Service Bulletin

SXS1000 #3

2016-2017 SXS1000 Series - Clutch Slipping PRODUCT IMPROVEMENT CAMPAIGN

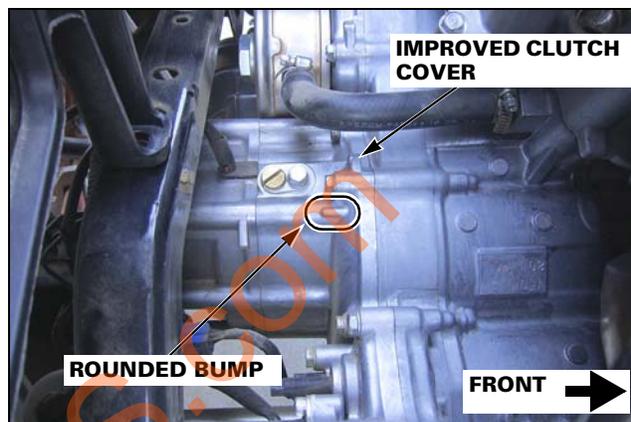
Before you begin the improvement procedure, check if it has already been performed on the unit by looking for the improved clutch cover which can be identified by the rounded bump cast into the cover at the location shown.

- If the improved clutch cover **is installed** – No further action is necessary.
- If the improved clutch cover **is not installed** – You may proceed with the IMPROVEMENT PROCEDURE section of this Service Bulletin.

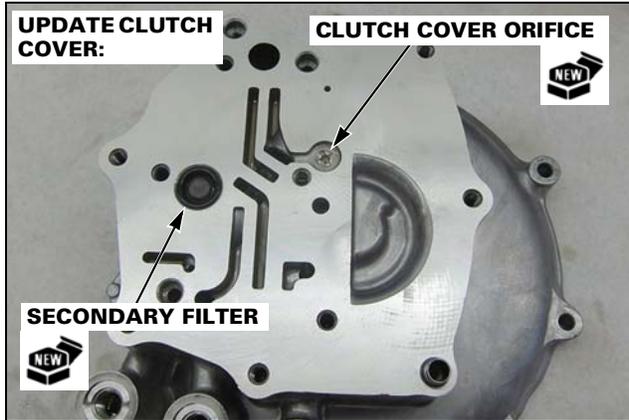
1. Install the update secondary filter into the update clutch cover in the direction shown.
Install the update clutch cover orifice by pushing it into the update clutch cover at the location shown.

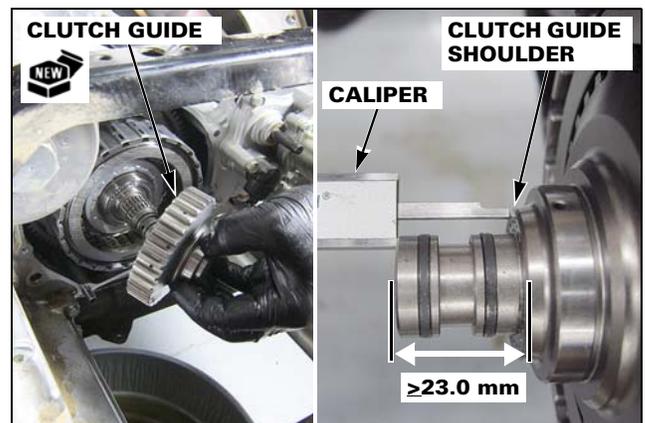
5. Replace the No. 1 clutch guide with the update part as shown.

Measure the depth of the clutch guide installation between the clutch guide shoulder and end of the mainshaft with a caliper as shown.

Minimum Depth: 23.0 mm

If the clutch guide installation depth is less than 23.0 mm, turn the guide back and forth while pushing it in until it seats fully.

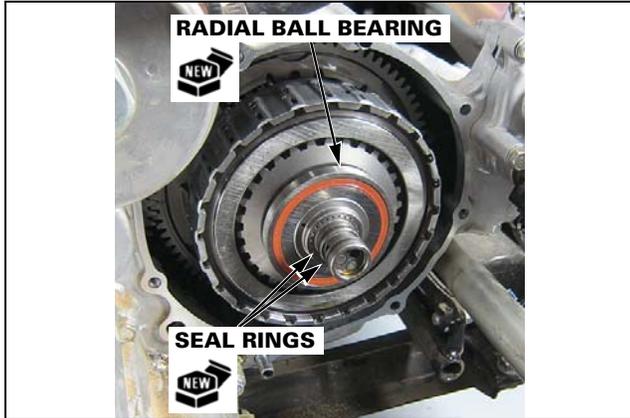
6. Replace the radial ball bearing with the update part as shown.
- The ball bearing seal (orange) should face out as shown.

Install the new seal rings onto the mainshaft as shown.
